Access Compliance Report

Public Rights-of-Way

(Curb Ramps)

Intersection ID: 53978	Main Street: CASRACK_ST	Cross Street: ABENDEGO_RD	Location:	N
ADA ID: 17C372735371	Ramp Type: PerpDiag	Initial Pass/Fail: Pass	Overall Compliance: No	Severity Score: 20

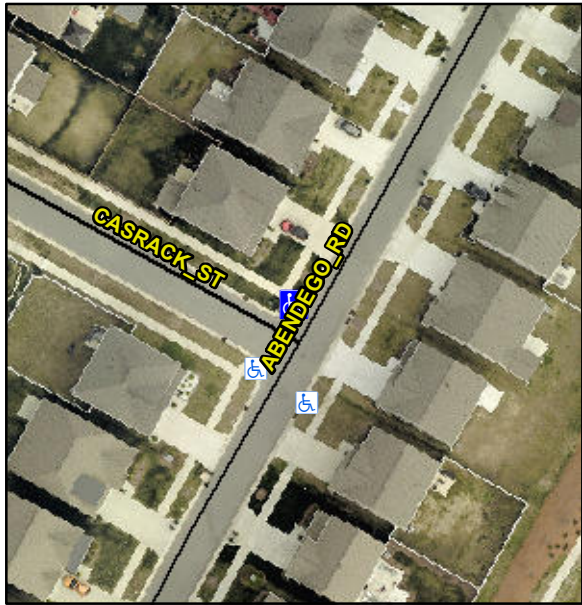
98.0			7.3		
			Yes			Yes		
			Ramp Width (in)			Ramp XSlope (%)		
			48.0			1.4		
			N/A			N/A		
		Flare Type LT			Sloped			
		N/A			N/A			
		Flare Slope LT (%)			6.3			
		N/A			N/A			
		Flare Traversable LT?			No			
		N/A			N/A			
		Flare Slope RT (%)			11.2			
		Yes			Yes			
		Landing Length (in)			68.0			
		No			Yes			
		Landing Width (in)			29.0			
		Yes			Yes			
		Landing Slope (%)			0.7			
		No			Yes			
		Landing X Slope (%)			2.3			
		N/A			No			
		Landing Curb? (Y/N)			No			
		N/A			No			
		Shared Landing?			No			
		Yes			No			
		Gutter Ponding?			No			
		No			No			
		Gutter Lip Ht (in)			1.0			
		N/A			N/A			
		Painted X Walk1?			No			
		X Walk 1 Direction			To W			
		N/A			N/A			
		X Walk 1 Width (in)			N/A			
		X Walk 1 Slope (%)			1.7			
		X Walk 1 X Slope (%)			2.3			
		N/A			N/A			
		Ramp inside XWalk1?			N/A			
		Road Slope (%)			3.0			
		Road X Slope (%)			4.0			
		Yes			Yes			
		Any Obstructions?			No			
		Obstruction Type			N/A

N/A			
					Yes			
					Surface Condition? (G/P)			
					Good

Codes/Mitigation Info/Possible Solution			Field Measurements/Component Compliance					
 Street 1 Name CASRACK ST Stop Condition-Street 2 StopSign Street 2 Name ABENDEGO RD Stop Condition-Street 1 None	Possible Solutions:		Compliance			Compliance		
	Remove & Replace Curb Ramp With Two New Directional Ramps or Equivalent. Remove & Replace Gutter.		Description			Description		
			Data			Data		
			N/A			Yes		
			Ramp Length (in)			Ramp Slope (%)
